# EVIDENCE IN THE MATTER OF PC 78

## Evidence of Gabi Wolfer, Senior Urban Designer/Town Planner, Selwyn District Council

### PROPOSED CHANGES TO ODP

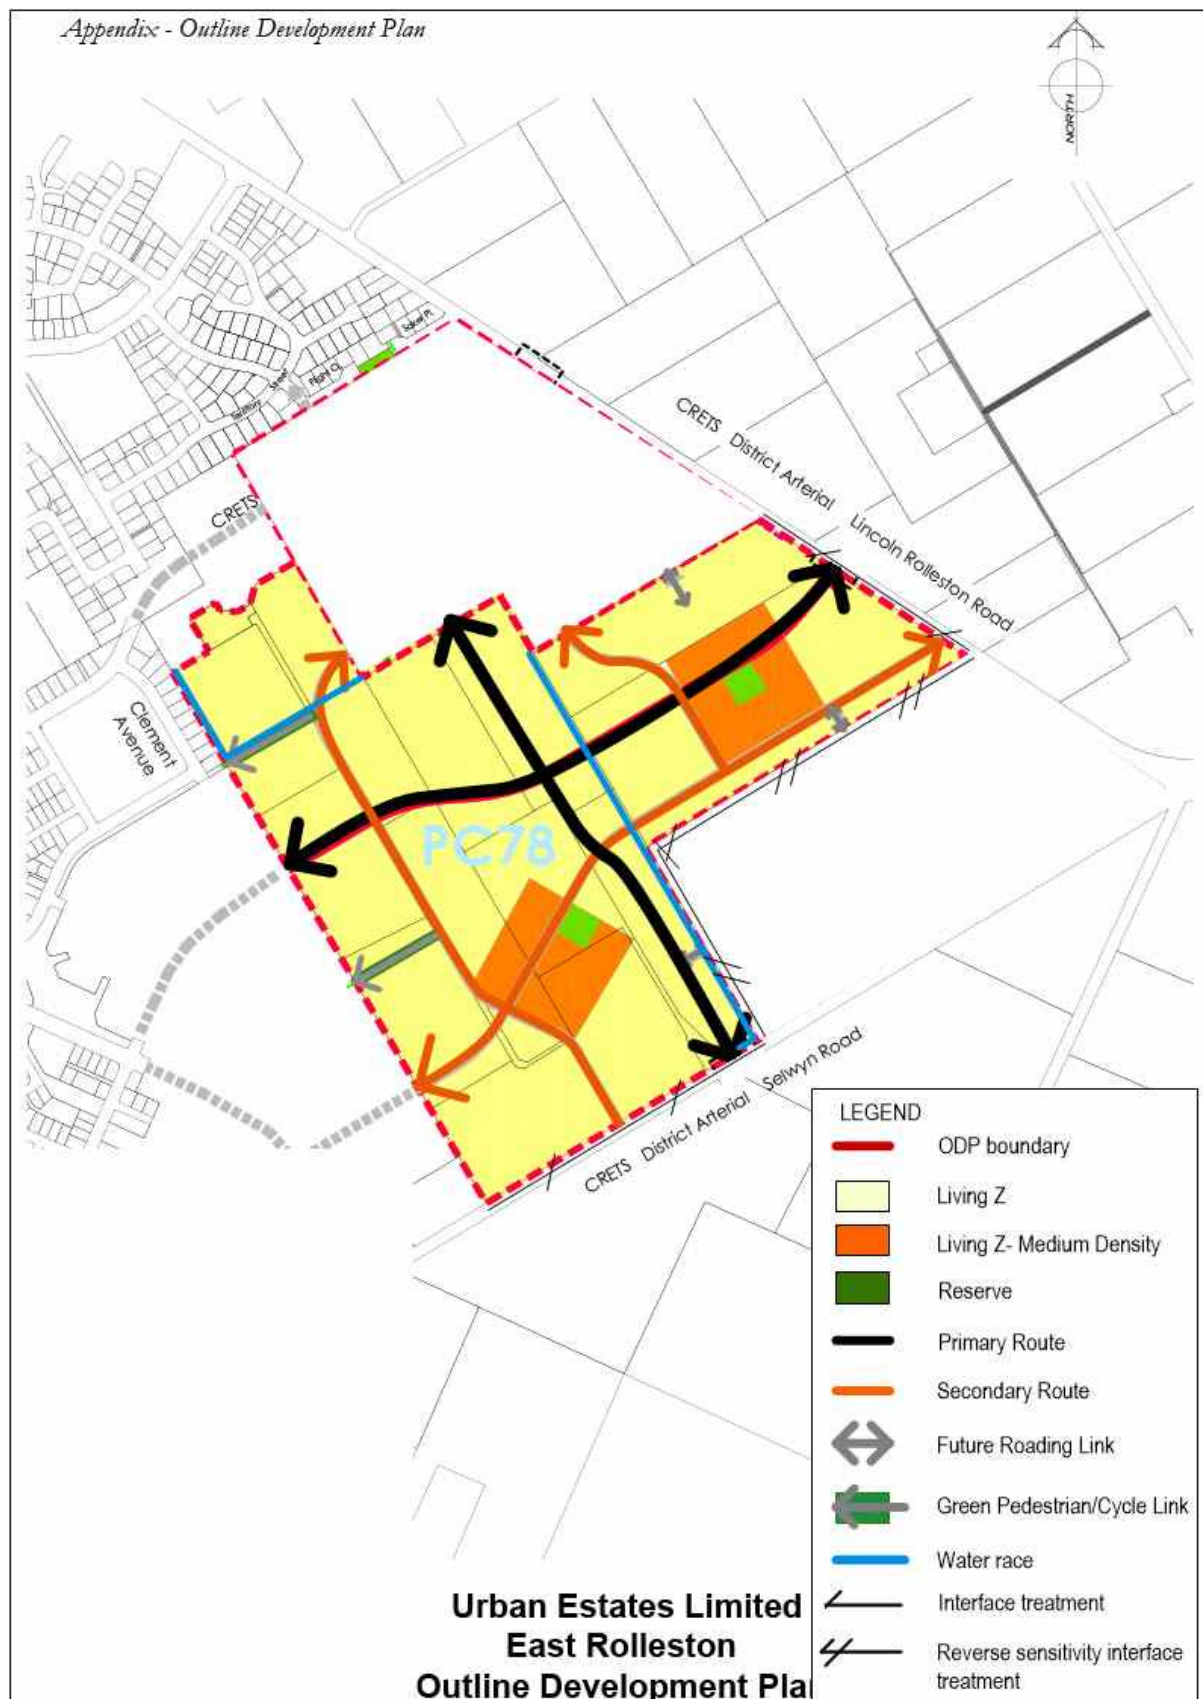
- 16.1. In terms of the display of the roading network I note that the main east –west connection is referred to as 'collector road' and all other roads are referred to as 'major intermediate'. Future roading is not labelled. To be in keeping with other ODPs in the District Plan and to establish a hierarchy within the proposed transport network I recommend the ODP identifies and labels the 'primary' and 'secondary' routes and that their different functions are addressed within the ODP text.

- 16.4. In terms of the reference to the roading network I note that the ODP refers to external road connections. For consistency with other ODP's in Appendix 38 of the Plan the legend needs to be amended to show a 'double arrow' instead of a hatched box.

- 17.1. I consider that the water race running through the proposed site is a historic feature of note that needs to be further assessed as an amenity feature and its alignment shown on the proposed ODP.

- 16.5. I recommend the ODP and the legend is amended as follows (see **Appendix 2**):
- 16.6. That the areas not included in PC78 to be removed from this ODP.
- 16.7. That the reference to 'collector road' is replaced with 'primary route' and corresponding text in the ODP is included as appropriate;
- 16.8. That the centrally located north-south connection that links with PP75 is referenced as a 'primary route' and corresponding text included as appropriate;
- 16.9. That the reference to 'major intermediate' is replaced with 'secondary route' and corresponding text included as appropriate;

- 16.10. That the reference to the two pedestrian/cycle routes to be replaced with 'green pedestrian/cycle link' and for them to be incorporated into the overall green network;
- 16.11. I recommend that the ODP plan legend is amended to show a 'double arrow' referring to a future link to adjacent sites;
- 16.12. That a note on the ODP is included to reference 'Interface treatment' along the Lincoln-Rolleston Road and Selwyn Road boundaries and corresponding text included as appropriate.

- 17.2. I recommend the ODP is amended as follows:
- 17.3. That the indicative location of Green links are shown, including where they accommodate off-road cycle and pedestrian links;
- 17.4. That the water race is shown;
- 17.5. That text be included that indicates how the central reserve is linked within the site and with surrounding public recreation and reserve space and how the water race may be addressed.

- 18.7. Replace 'roading collector' and identify the north-south connection as a 'primary route';
- 18.8. Replace 'collector roading' and identify the east-west CRETS connection as a 'primary route';
- 18.9. Retain a 'secondary route' to Lincoln Rolleston Road;
- 18.10. Amend the ODP's key to show a 'double arrow' referring to a future (roading) link outside the proposed ODP boundary;
- 18.11. Add note 'Interface treatment' along the Lincoln Rolleston and Selwyn Roads frontages;

- 18.12. Add note 'Reverse sensitivity treatment' along the internal boundary with Lot 3 DP 48064.

- 18.13. Show water race alignment.
